ATTACHMENT

Re: U.S. Department of Energy Clean Hydrogen Production Standard (CHPS)
Draft Guidance

Figure 1: A lifecycle system boundary enables consistent and comprehensive evaluation of diverse hydrogen production systems. Examples of key emission sources within each step typically considered in the boundary are shown above.¹¹

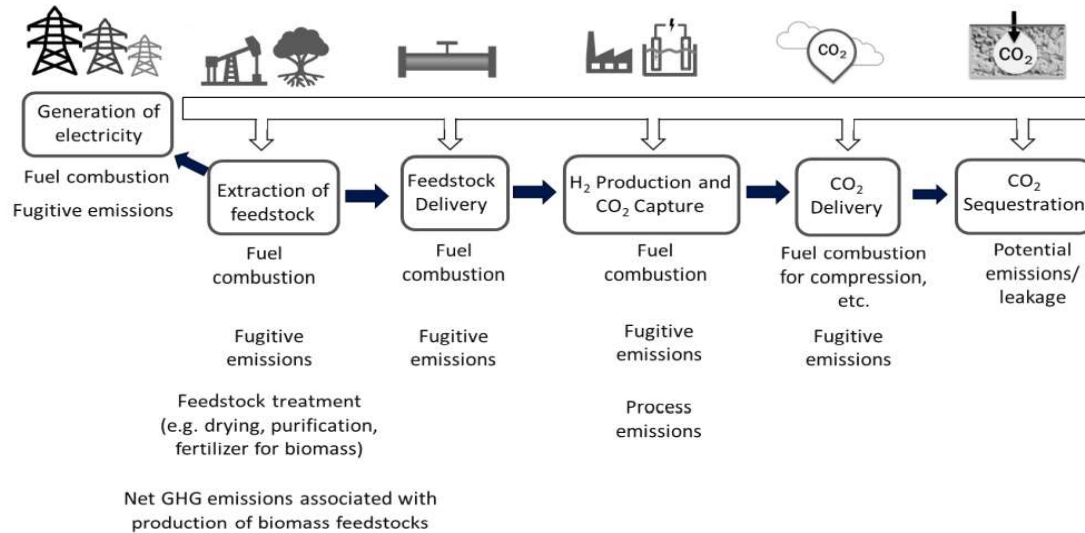
Response: Figure 1 (copied below) appears to include the major steps associated with a lifecycle analysis of hydrogen production. The phrasing “extraction of feedstock” seems a little targeted to fossil fuel sources. We would suggest clarifying where organic waste biomass feedstocks would fall. In particular, we recommend that the reference to “Net GHG emissions associated with production of biomass feedstocks” should be clarified to ensure that this step includes both avoided emissions benefits from organic waste to RNG for all GHGs (e.g., methane) as well as sinks of CO₂ as biogenic material (that eventually becomes the organic waste) is grown.
